8CH, 12 BIT A/D  
 WITH SPI INTERFACE  
 604-00062  
 MCP3202

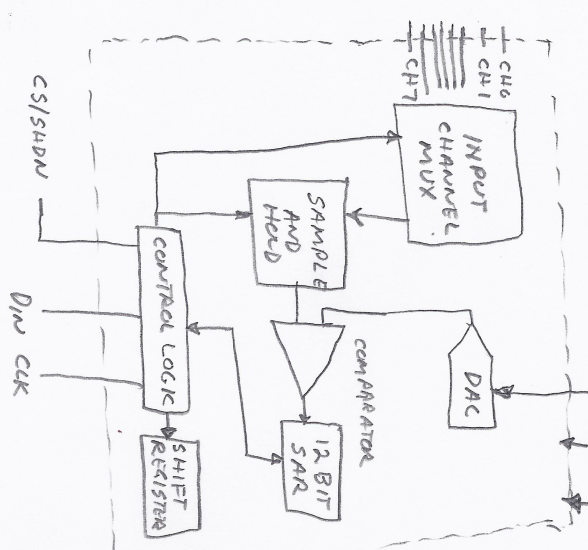
- Q1. How does LM324 connect to 12 BIT A/D?
- Q2. Am I missing a filter between sensor & A/D?
- Q3. MEASUREMENT SYSTEMS INSTRUMENTATION AMP IS DIFFERENT THAN THE ONE MICROCHIP SUGGESTS @ WWW.MICROCHIP.COM/DOWNLOADS/EN/APPNOTES/00695a.PDF. (PAGE 80-12, 106-05)
- Q4. IS THERE SAMPLE CODE AND WIRE HOOK UPS TO CONVERT THE 12 BIT A/D TO THE BASIC STAMP 2 EEPROM TO STORE AND DISPLAY DATA?
